Operational Noise and Vibration Review Addendum

Epping to Thornleigh Third Track Alliance

Title ETTT Operational Noise and Vibration Review Addendum
 Document Number/Ref: ETTT-ETTTAL-CS-003474

Figure 1. Aerial image showing the location of the five sections of noise barrier 1

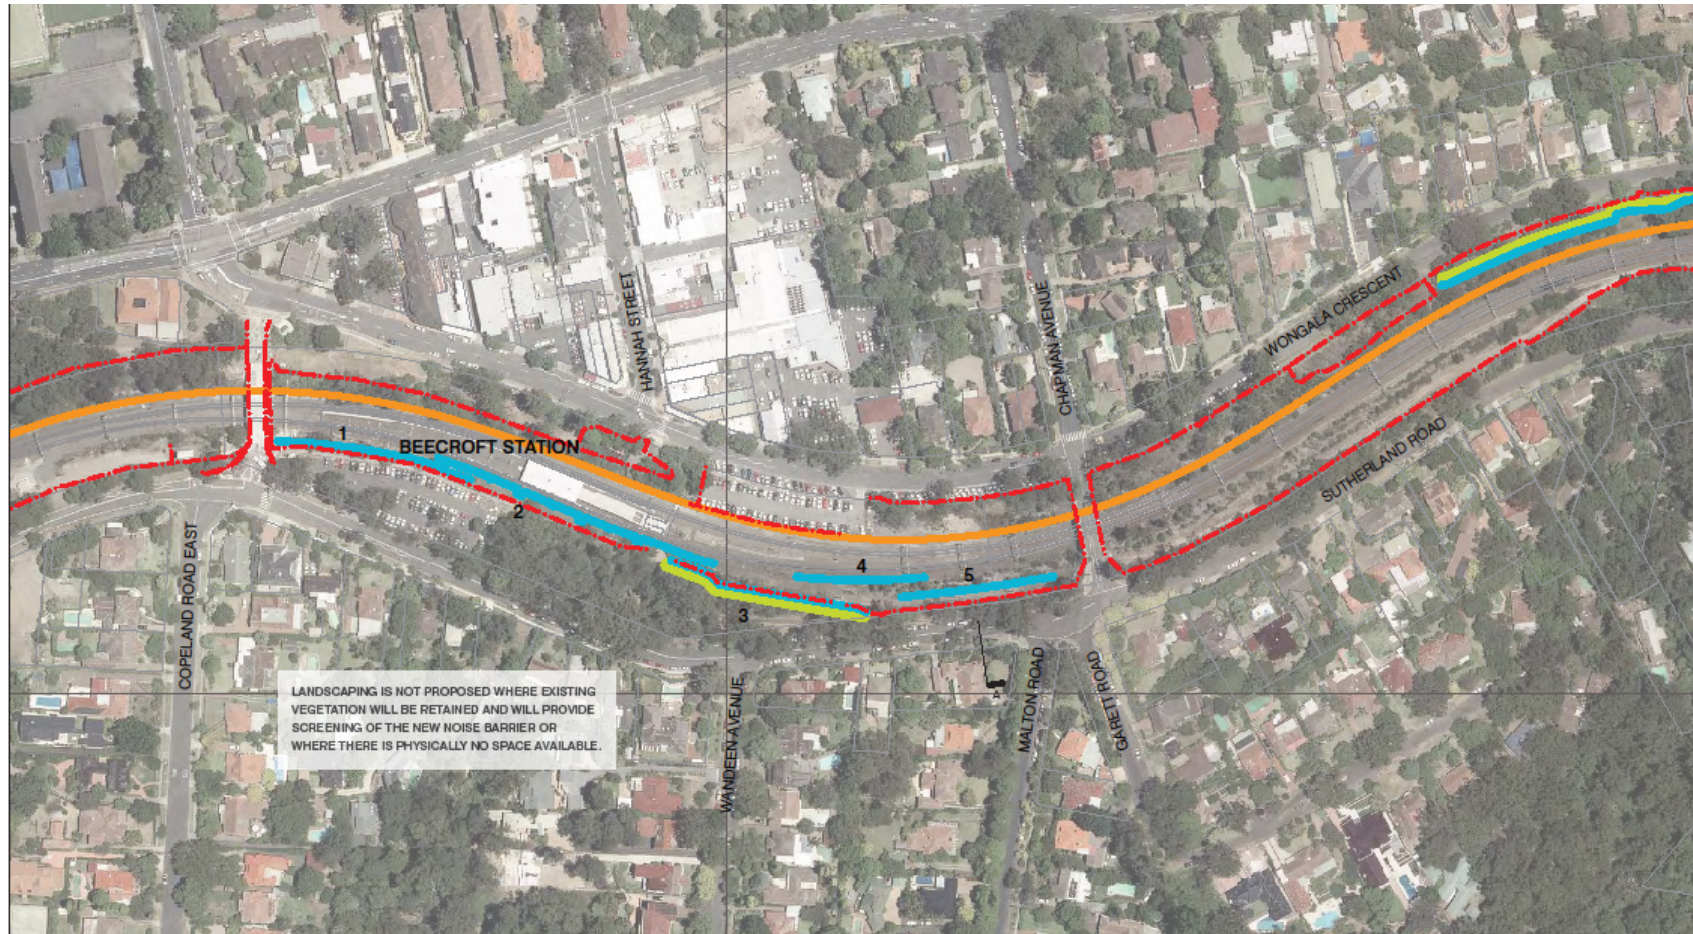
The approved ONVR proposed a low height noise barrier inside the rail corridor between Copeland Road and the Chapman Avenue Bridge. Further design and investigations confirmed that the low height barrier could not be built close to the track due to safety concerns and space constraints. These constraints are as a result of requiring maintenance access to the following pieces of infrastructure:

As a result of the above issues, a conventional noise barrier ranging between 1.5 and 5.5 metres high, was proposed to replace the low height barrier. The barrier has been constructed in five overlapping sections along the eastern side of the rail corridor (Sutherland Road side). The barrier will provide the same acoustic benefit as the low height noise barrier.

The majority of the noise barrier is made from aerated concrete panels (providing a solid barrier between the track and residential receiver), with the remainder comprised of brick. From the existing Beecroft Station pedestrian underpass east along the commuter car park, the barrier takes the form of an upward extension of the existing brick portal. The extension of the brick portal was identified to be used (instead of the aerated concrete) as it maintains the aesthetic heritage values of the station area whilst still providing effective treatment to mitigate the noise impacts.

The varied height conventional noise barrier described above will provide the same acoustic benefit as the originally proposed low-height noise barrier. The approved ONVR identified that either a low height or a conventional height noise barrier would be acoustically feasible at this location (see section 8.8.8 of the ONVR).

When the low height noise barrier (1m above top of rail at 2.25m from track centre line) is relocated to 4.5m from the track centreline in the form of a conventional noise barrier, the resulting calculated noise levels for all rail sources increase by up to 0.5 dB for LAeq and 1.0dB for LAm_{ax} at the nearest sensitive receivers. Raising the revised barrier height by 0.5m at the relocated position provides the same level of mitigation as per the approved ONVR or better at all nearby receivers, except for two locations where a deficit in mitigation of 0.1dB is predicted. This level of mitigation is considered acceptable.

Figure 5. Aerial image showing the location of the sections of noise barrier 2

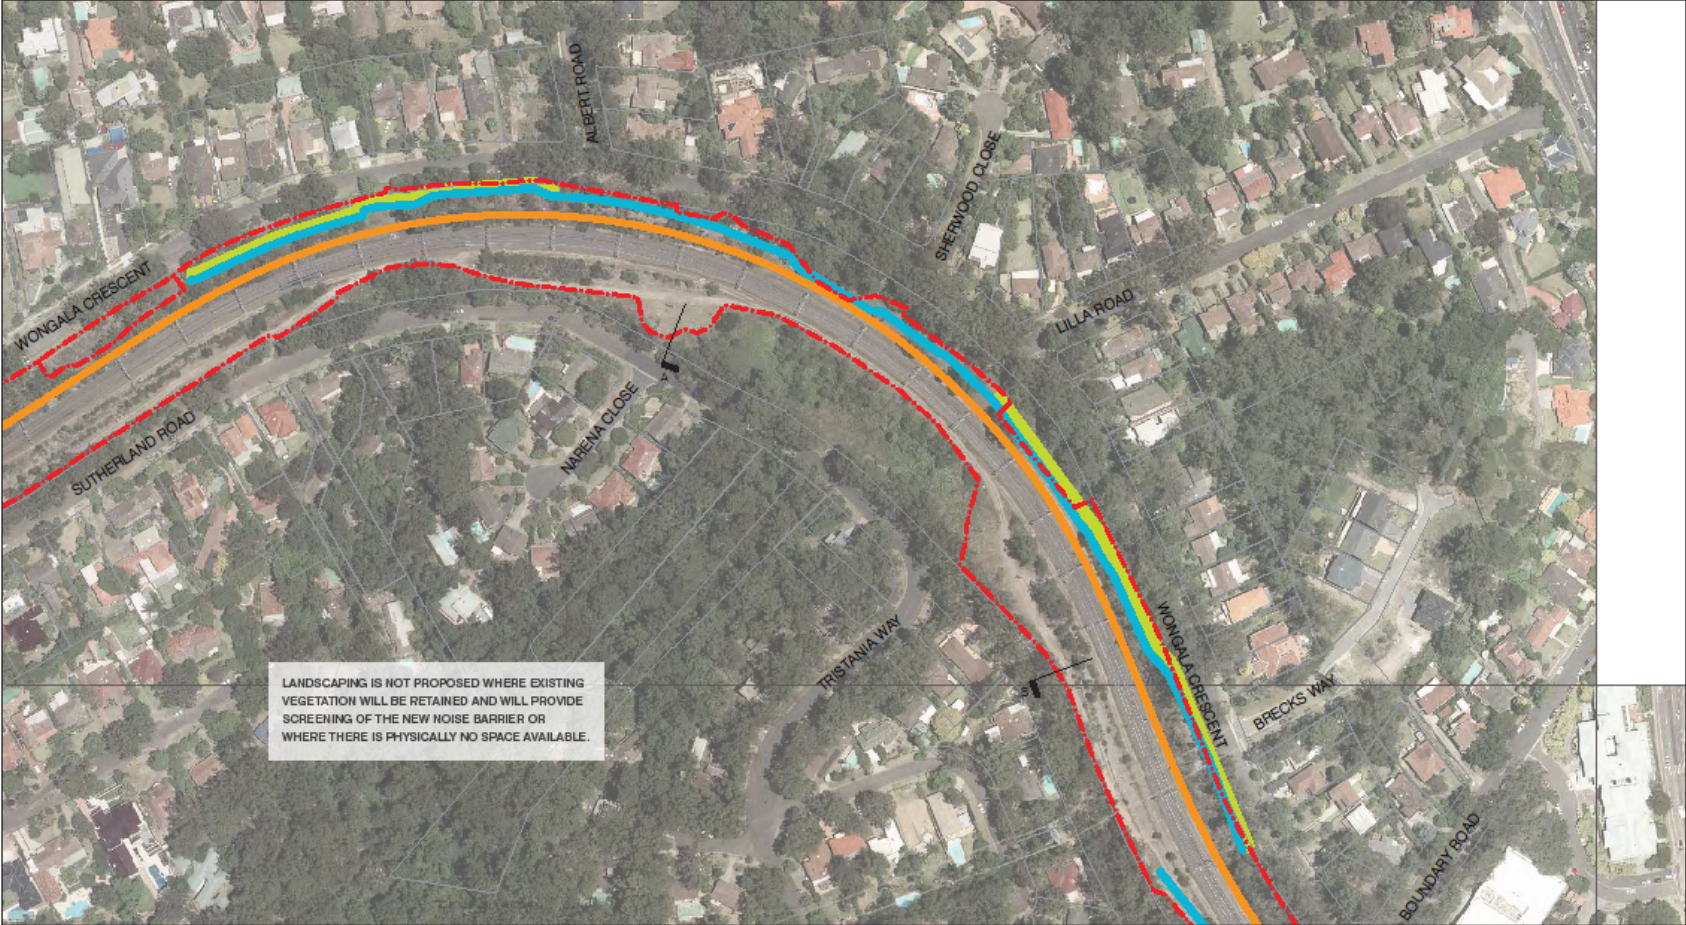
The approved ONVR identified that a noise barrier approximately 660 metres long would be built from approximately 49 Wongala Crescent, Beecroft to Brecks Way, Pennant Hills. The ONVR also identified that a large amount of Blue Gum High Forest, an endangered ecological community, would need to be removed to construct the barrier in this area. During the detailed design of this noise barrier ETTT identified ways to minimise impacts on vegetation through an alternate location and construction methodology. This was achieved primarily through two means:

- changing the alignment of the barrier to be close to the rail-line
- shortening the barrier by approximately 100m (and providing property treatment instead).

The barrier has been constructed closer to the rail corridor boundary and the length of the barrier reduced by approximately 100 metres at the northern end to reduce impacts on the Blue Gum High Forest community (see map below). By shortening this barrier, there were five properties that required property treatment.

To achieve the same barrier performance as the ONVR noise wall, the barrier was increased in height by up to 0.9 m in the vicinity of an existing gully near 61 Wongala Crescent, Beecroft. This localised change in height meant the noise barrier would achieve the same noise mitigation performance as that proposed in the approved ONVR for receivers in the vicinity of the gully.

The revised noise barrier alignment also produces reduced barrier performance of between 0.5 dB and 1.9 dB at 14 receiver buildings that were not triggered for treatment under the approved ONVR. Through implementation of the above noise barrier height changes, the number of these receivers is reduced to 11 in the vicinity of Lilla Road, Beecroft. To achieve the same barrier performance as the noise barrier in the approved ONVR, the revised barrier was raised in the vicinity of these receivers by up to 1m to achieve the same noise performance as the ONVR design.

The revised noise barrier alignment was shortened at the northern end of the alignment near 121 Wongala Crescent, Beecroft. A comparison of the revised noise barrier alignment with the performance of the noise barrier developed for the approved ONVR indicated the predicted LAeq and LAmax noise levels at six (6) receivers in the vicinity of the noise barrier shortening would potentially increase by up to 1.9 dB as a result of the modification.

Whilst these properties did not qualify for treatment under the approved ONVR, five of the properties were located behind the ONVR noise barrier and would have experienced some benefit. As a result of this, the ETTT Alliance has contacted the five properties which were located behind the barrier in its original form. These properties have been offered property treatment measures so that they are not disadvantaged by the design change.
